SPRINGDALE

To: Planning Commission
From: Niall Connolly, Principal Planner
Date: August 15th, 2025
Re: Design Development Review Revision, New Residence at 54 Hummingbird Lane

Proposed Revisions

Figure 3. Revised Access now proposed, with separated parking areas

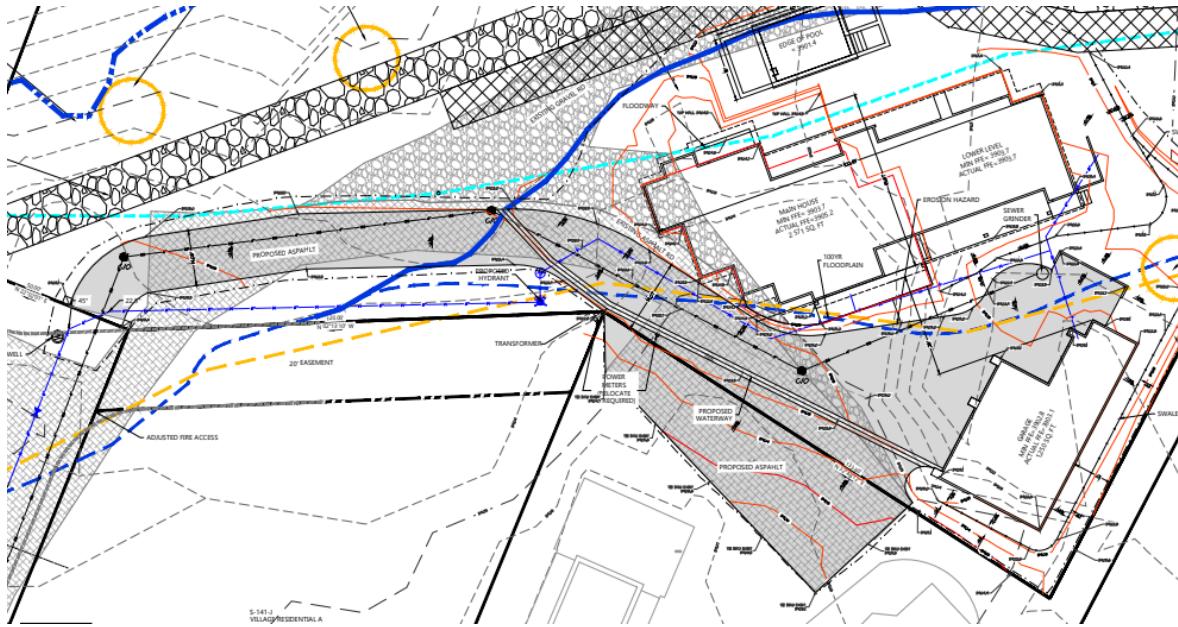
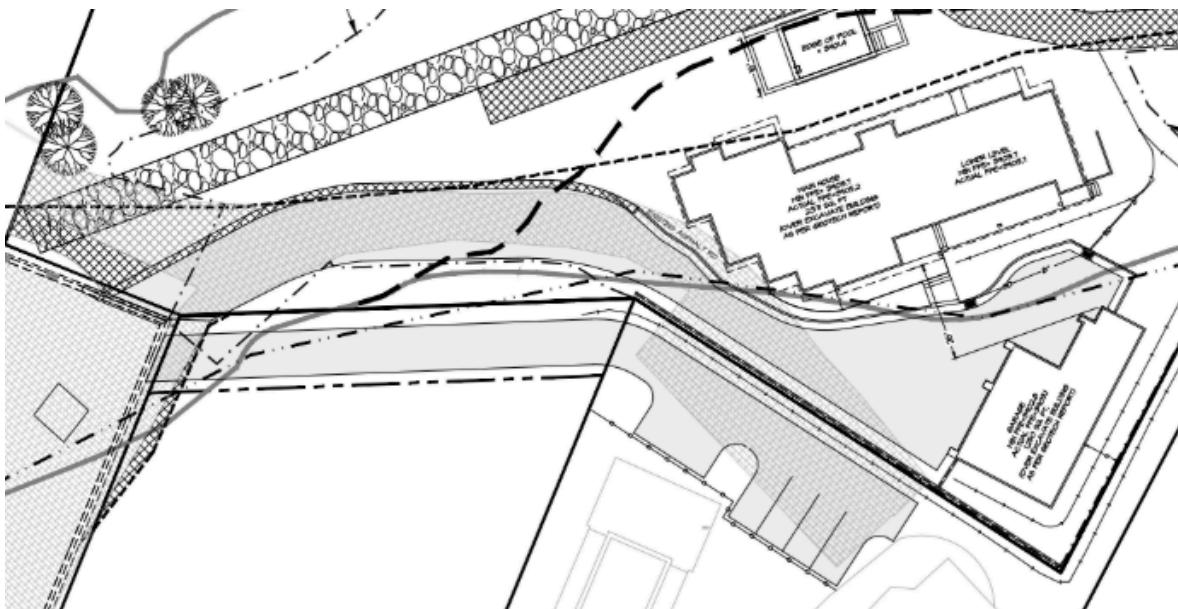
The approved plans retained the existing shared driveway through no. 54, and then a parking lot which would be shared by both no. 44 and 54. The access layout now proposed would separate the access and parking of these two properties. No. 54 would continue to use the same access, and have its own parking area. No. 44 would now be accessed through a new driveway passing through the yard of no. 50. There is an existing easement which allows them to create this new driveway. They would also now have their own parking area.

Figure 4. Easement through no. 50 which benefits no. 44

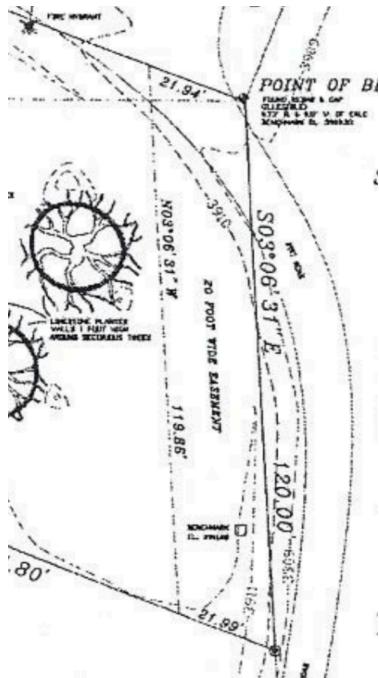
- Firstly, for the new driveway through the yard of no. 50 to access no. 44. Although this has not been used until now, an easement already exists here.

Figure 5. New easement that will be required to create fire truck access to no. 54

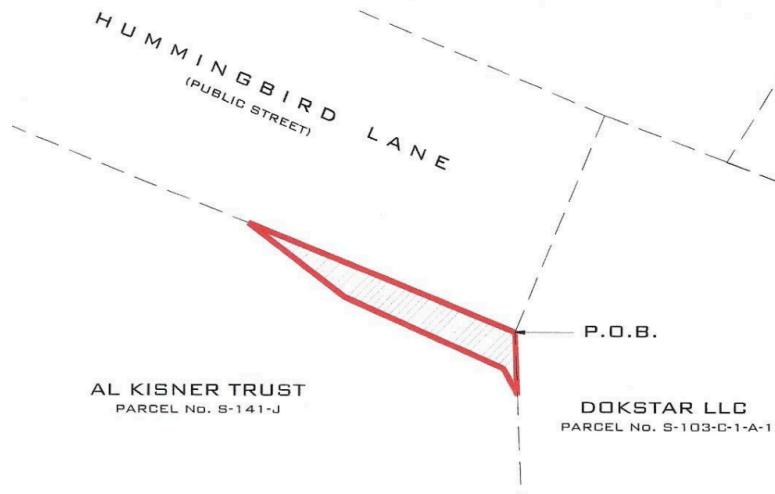
- Secondly, an additional area of the yard of no. 50 will be needed to benefit no. 54 (the application property). This is to allow fire truck access. A 20 ft wide fire access is required, and this additional area of land is needed to get around the Town's pump house which is situated at the bottom of Hummingbird Lane. No such easement exists at present, however Town staff has been presented with an unsigned draft of this easement. Fire district approval is part of the building permit stage. A signed and recorded version of this new easement will be required before the building permit can be issued.

SITE GRADING AND DRAINAGE PLAN
FOR
SNOW LEOPARD
54 E. HUMMINGBIRD LANE
SPRINGDALE, UTAH

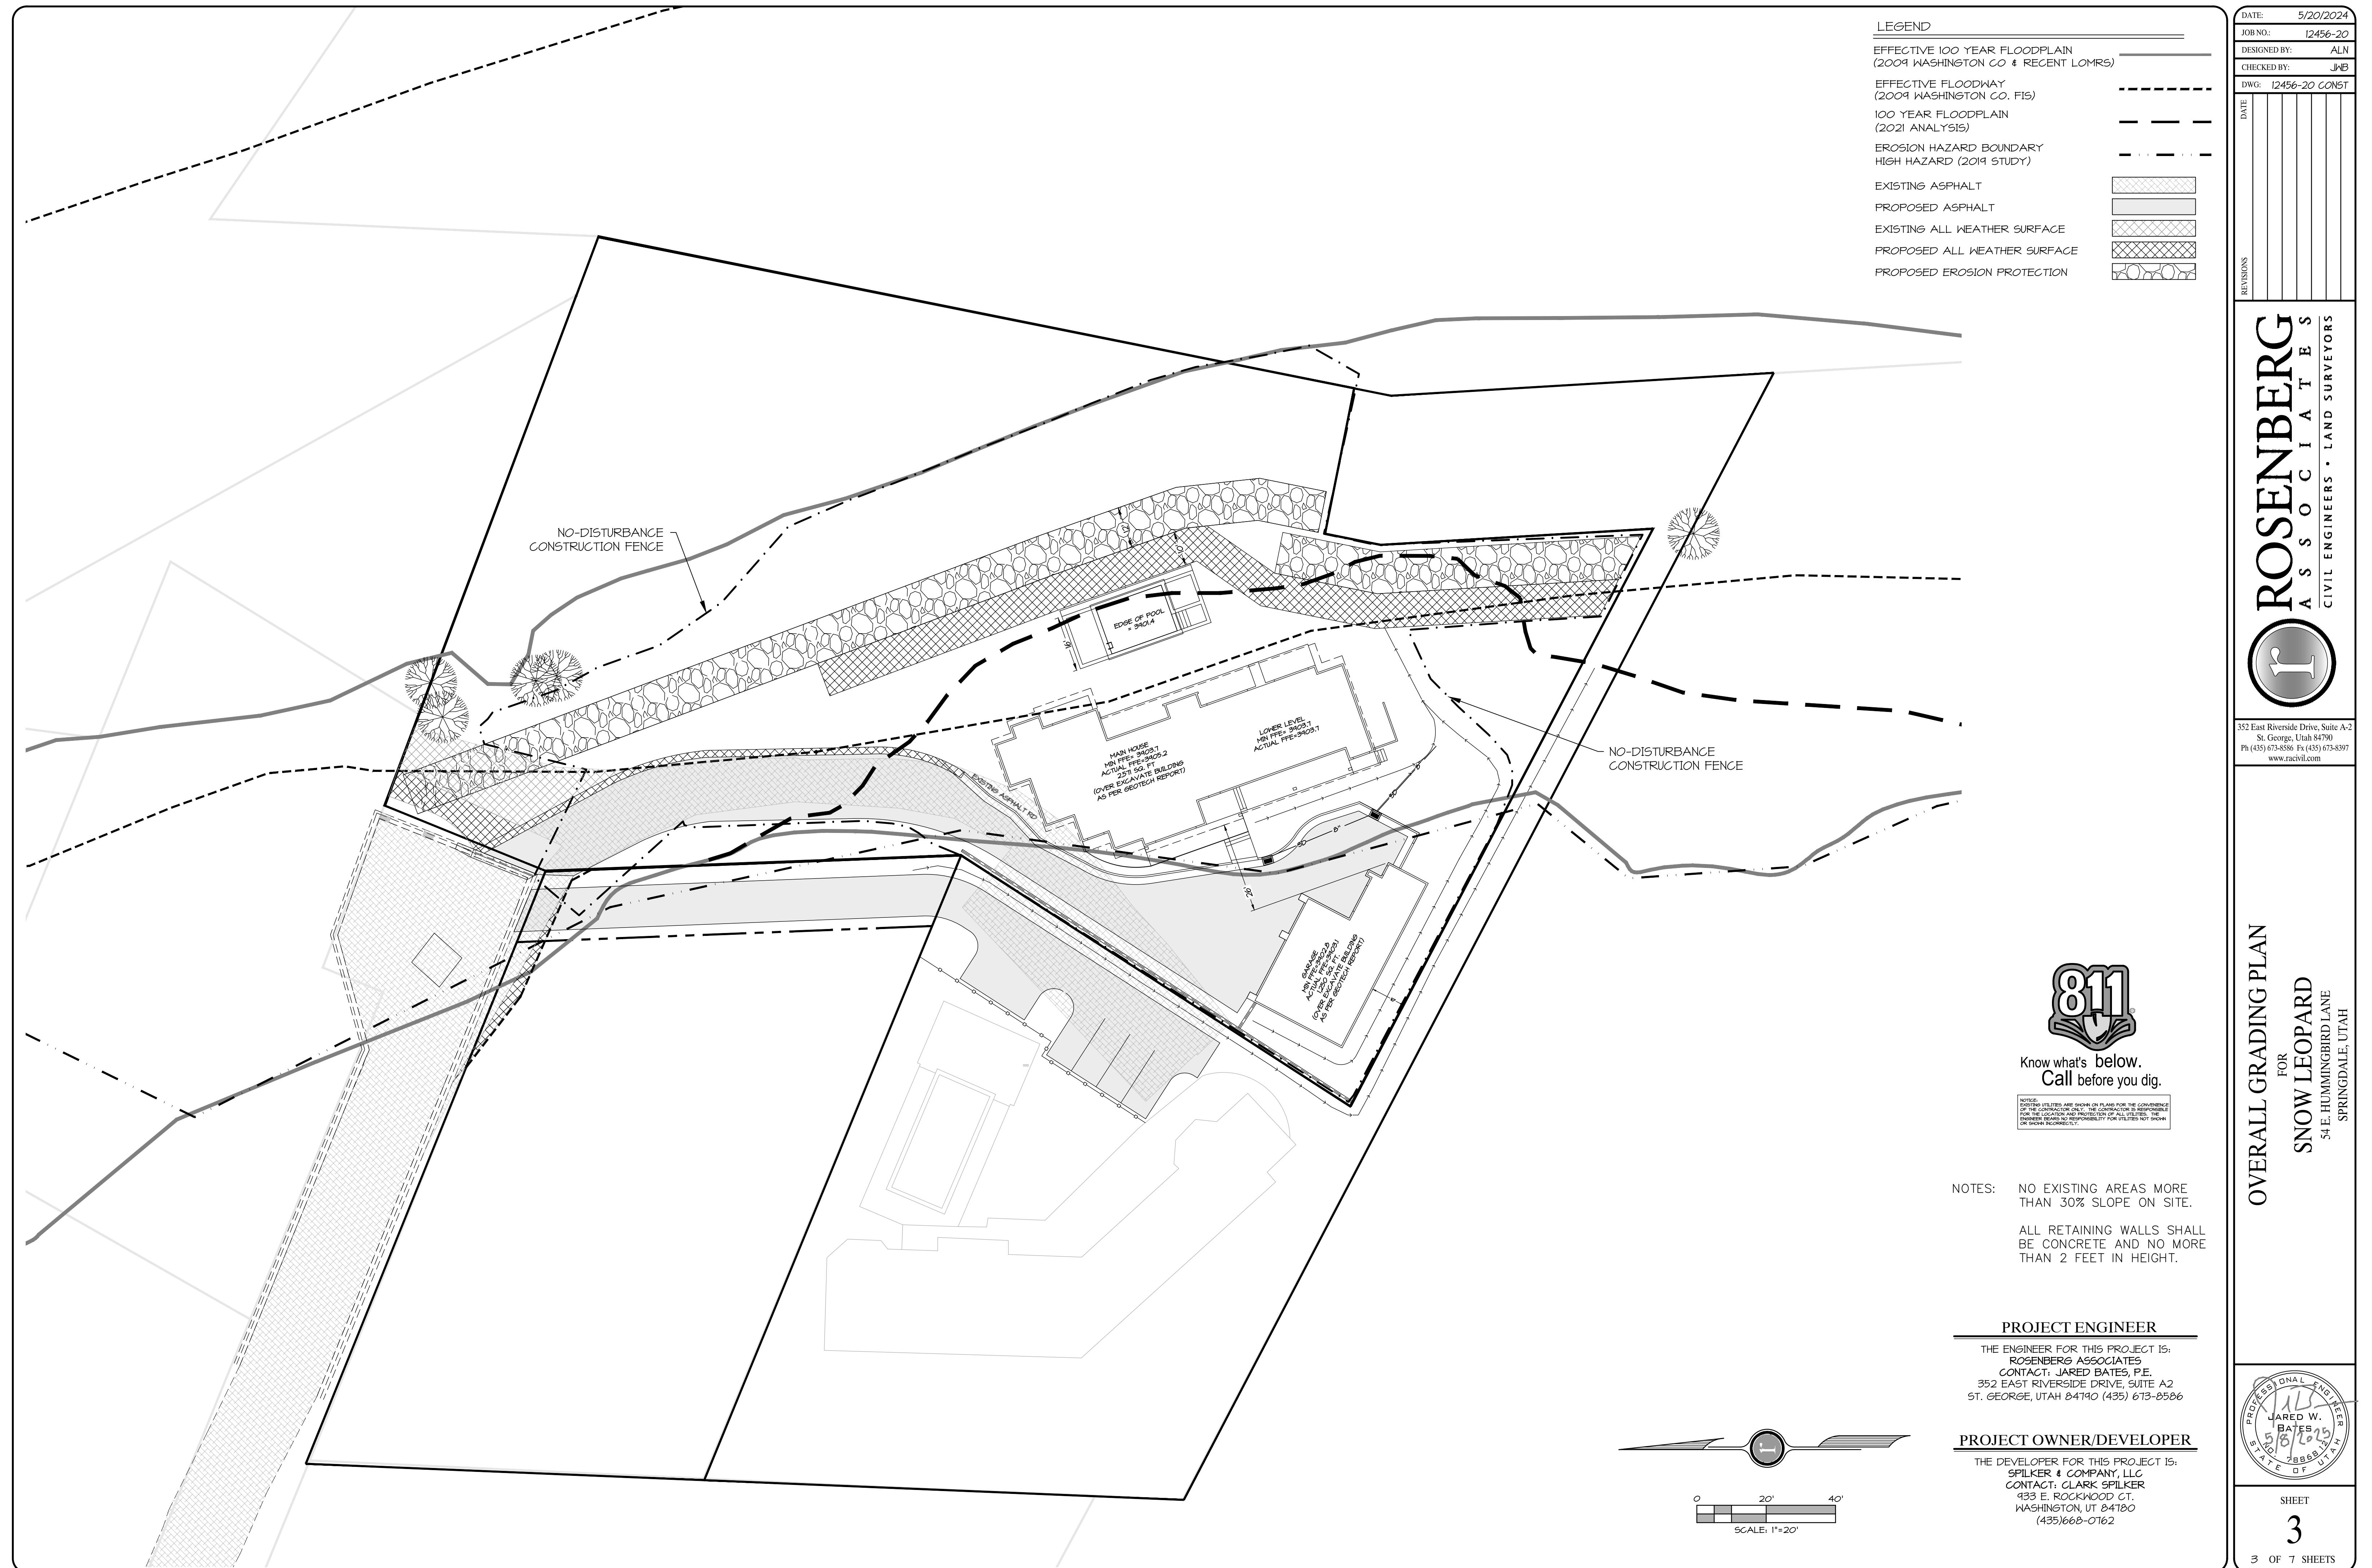
- The approved plans showed the roof of the house as standing seam metal. The plans now show the roof as EDPM membrane with aluminum flashing. This should comply with the Code so long as the color of the roof is on the Town color palette and the aluminum is non-reflective.
- Sheet 4 of the Civils Plans (Site Grading and Drainage Plan) by Rosenberg Engineers shows re-grading on the riverward side of the erosion protection trench. This was not shown on previous grading plans. This is potentially problematic because the flood modelling that was done in support of the floodplain development permit and erosion permit to show “no-rise” was not based on this re-grading. Staff therefore recommend that if the planning commission approves these revised plans, the approval is conditional on the grading being as originally shown, and not this new arrangement.

<p>The re-grading shown on the riverward side of the erosion protection on Civil Sheet no. 4 (Site Grading and Drainage Plan) is not approved. Any grading in this area must conform to the plans previously approved with the floodplain development permit, unless further hydraulic and</p>	<p>This condition is recommended to ensure that any re-grading in the floodway complies with the Town's ordinances and does not lead to a rise in the base flood elevation.</p>

<p>hydrological modelling is provided which demonstrates that any such re-grading will not lead to a rise in the base flood elevation on or off site.</p>	
<p>This revised approval does not include the new parking area shown on the plans at no. 44, nor the new driveway through no. 50's yard to serve no. 44. A separate permit application will be required for approval of those improvements.</p>	<p>These elements of the plans are indicative only, and the property owners in question would need to make that permit application.</p>
